SI B61 10 15
General Electrical Systems

SB-10058426-3128

June 2015
Technical Service

i8: Retrofitting High-Voltage Battery Ground Cables

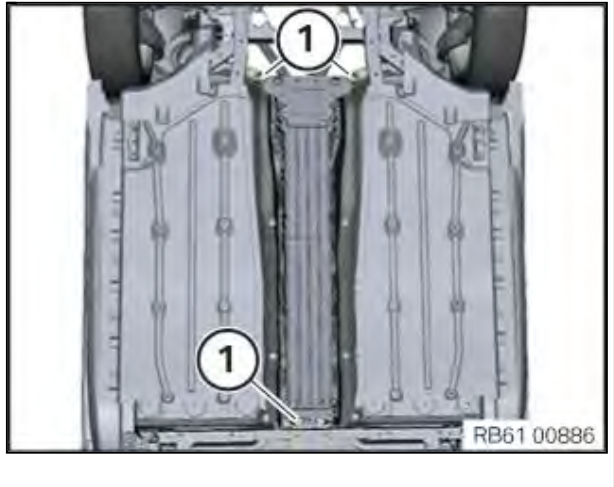
After HV battery (or front axle support) removal and reassembly, HV battery grounding points contact resistance (on both axles) may increase. As a result, the HV battery housing grounding path (resistance value) will be incorrect.

<p>If work was performed on the vehicle which made it necessary to loosen the M10 x 40 mm screw connections between the HV battery and front/rear axle carries (1), follow the procedure steps below.</p>
--	---

1. Inspect whether the additional ground cables are already fitted between the HV battery housing and the front/rear axle carries. If the cables are not found, retrofit both ground cables using the repair instructions below:

2. If the additional ground cables were already installed, clean the corresponding contact surfaces on the HV battery and front/rear axles, following appropriate precautions:

On all contact surfaces, sand the oxidized coating using a fine sandpaper (P500 or finer) with a planar sanding block.

Do not touch the contact surfaces after they have been sanded, and do not use any cleaning agents. Using cleaning agents (e.g., brake cleaner) may promote the formation of oxide coating.

To prevent oxidation of the surfaces, the M10 x 40mm screw connection for the grounding cables must be established within 10 minutes after sanding.
